IN THE UNITED STATES PATENT AND TRADEMARK OFFICE

Applicant: Mark James Yunker)
Serial No.: 09/904,387) Group Art Unit: 3653
Filed: 07/12/2001) Examiner: Daniel K. Schlak
For: Slide For Sorting Machine)

RESPONSE TO OFFICE ACTION

FIG. 1

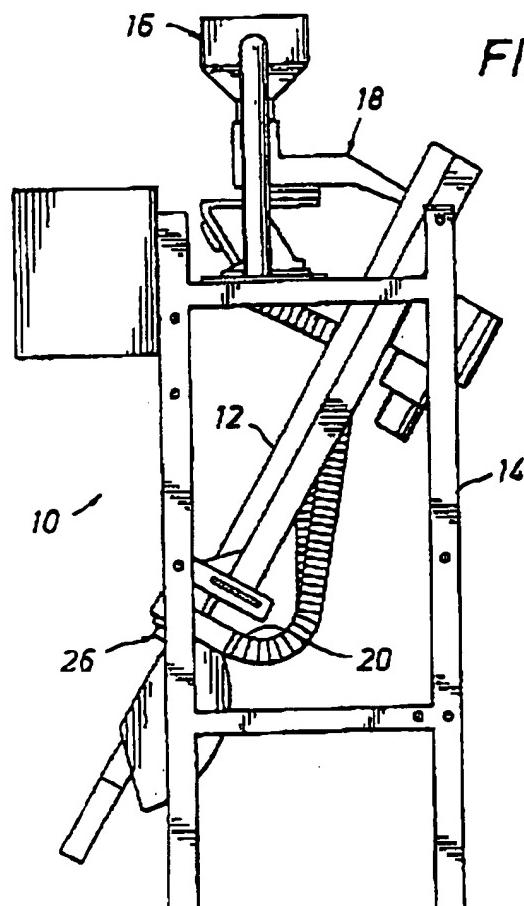
The applicant offers one (1) sheet of substitute drawings to include designations of --Prior Art-- on Figs. 1 and 2. Figs. 3 and 4 each depict a representative product guide 50. Product guide 50 is an aspect of the present invention, so marking of Figs. 3 and 4 as Prior Art has been deferred pending action on this response.

The applicant offers substitute drawings for Figs. 1 and 2 to include designations of --Prior Art--. Figs. 3 and 4 each depict a representative product guide 50. Product guide 50 is an aspect of the present invention, so marking of Figs. 3 and 4 as Prior Art has been deferred pending action on this response.

-PRIOR ART-
